From: Joyce Christie
Sent: 29 May 2020 13:04
To: Gemma Magnuson
Subject: Temple Mill

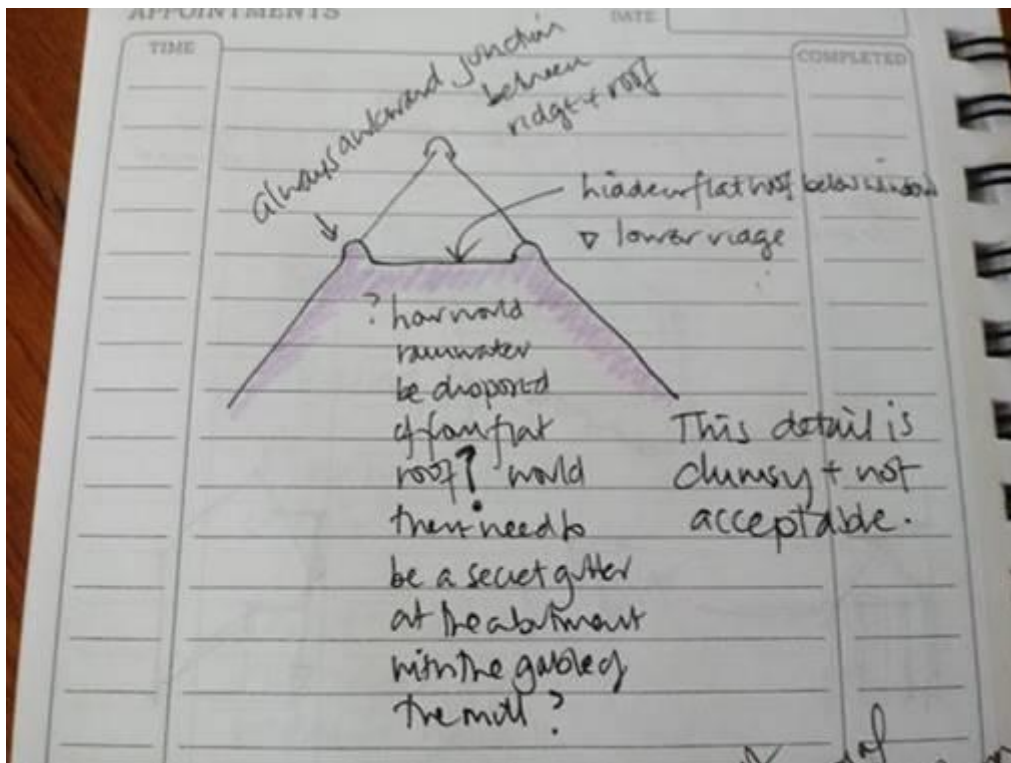
- The proposed plan and the survey plan show the brick steps will be built in a different form, historically they were wider to the south, tapering to the north as shown on the survey drawing, and old plans show the steps projected beyond the NE corner of the mill. The photo below appears to show the block wall does not align between the steel posts but has been built within

the area of the surveyed steps, almost parallel with the gable of the mill rather than the steel grid which is shown on the proposed drawings.
